UNITED STATES PATENT AND TRADEMARK OFFICE

10/568,272

Eiko Tagusari

Office Action Summary	Application No. 10/568,272	Applicant(s) TAGUSARI, EIKO	
	Examiner JAMES L. CLINE JR.	Art Unit 4187

Fig. 4
of Moroi et al.

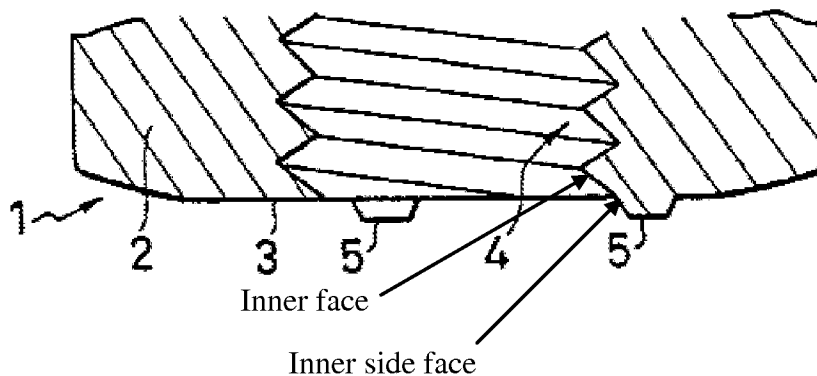
15. Regarding claim 1, Moroi et al. discloses a similar lock nut device (1) (Figs. 1-9 of Moroi et al.), the device comprising:

- a nut body (2) having a threaded hole (4), a seat surface (3), and a plurality of projections (5) formed on said seat surface;
- wherein each of said projections is made from the same material (Fig. 4) as that of said nut body and has an inner side face (Fig. 4) being an extension of an inner face (Fig. 4) of said threaded hole; and
- wherein said projections are crushed (Figs. 5(c) and 6) when said nut body is threadably engaged with a bolt (6) and fastened against it by a fastening nut (7).

16. However, Moroi et al. fails to disclose a groove formed continuously and concentrically from a circumferential edge of a threaded hole of a seat surface of a nut body; a plurality of projections formed in said groove, each of said projections having an outer side face extending in a tilted manner from the border between the seat surface and the groove of said nut body toward a center of the nut body; and a depth of said groove such that the projection crushed when said nut body is threadably engaged with a bolt and fastened against it by a fastening nut does not enter the space between a seat surface of said fastening nut and the seat surface of said nut body.

Fig. 1 of Heighberger

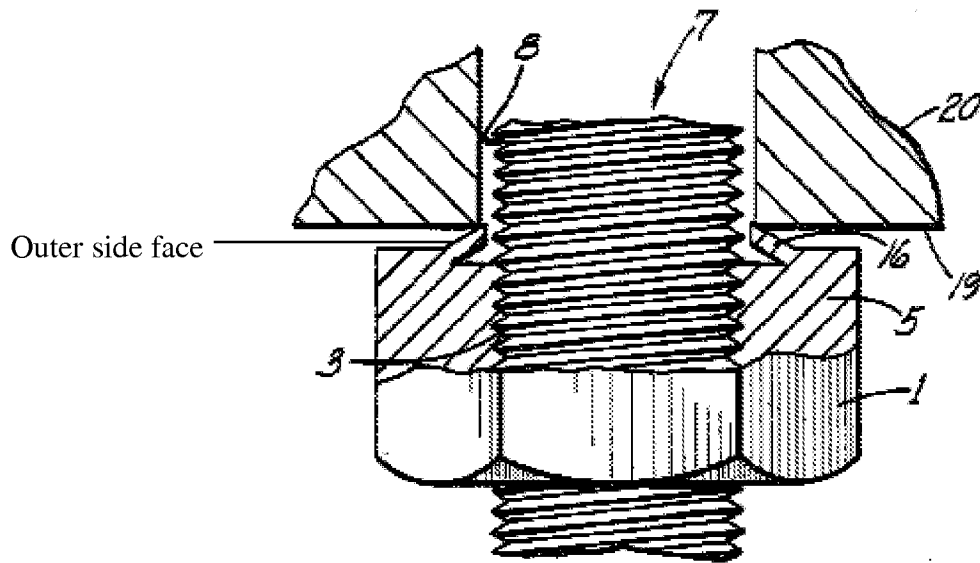
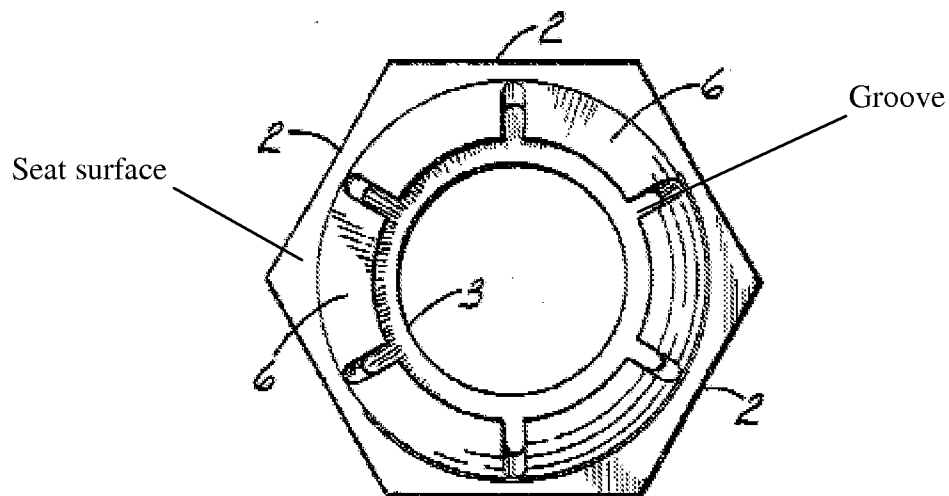
17. Heighberger teaches a lock nut device (Figs. 1-5 of Heighberger) including a groove (Fig. 2) formed continuously and concentrically from a circumferential edge of a threaded hole (3) of a seat surface (Fig. 2) of a nut body (1); a plurality of projections (6) formed in said groove, each of said projections having an outer side face (Fig. 1) extending in a tilted manner from the border between the seat surface and the groove of said nut body toward a center of the nut body; and a depth of said groove such that the projection crushed when said nut body is threadably engaged with a bolt (7) and fastened against it by a fastening nut (20) does not enter the space (Fig. 5)

between a seat surface (19) of said fastening nut and the seat surface of said nut body; for the purpose of controlling deformation of the projections toward the bolt (C3 / L13-21; L31-38).

18. Therefore, it would have been obvious to one of ordinary skill in the art at the time of the invention to modify the lock nut of Moroi et al. to have a groove formed continuously and concentrically from a circumferential edge of a threaded hole of a seat surface of a nut body; a plurality of projections formed in said groove, each of said projections having an outer side face extending in a tilted manner from the border between the seat surface and the groove of said nut body toward a center of the nut body; and a depth of said groove such that the projection crushed when said nut body is threadably engaged with a bolt and fastened against it by a fastening nut does not enter the space between a seat surface of said fastening nut and the seat surface of said nut body, as taught by Heighberger, for the purpose of controlling deformation of the projections toward the bolt.
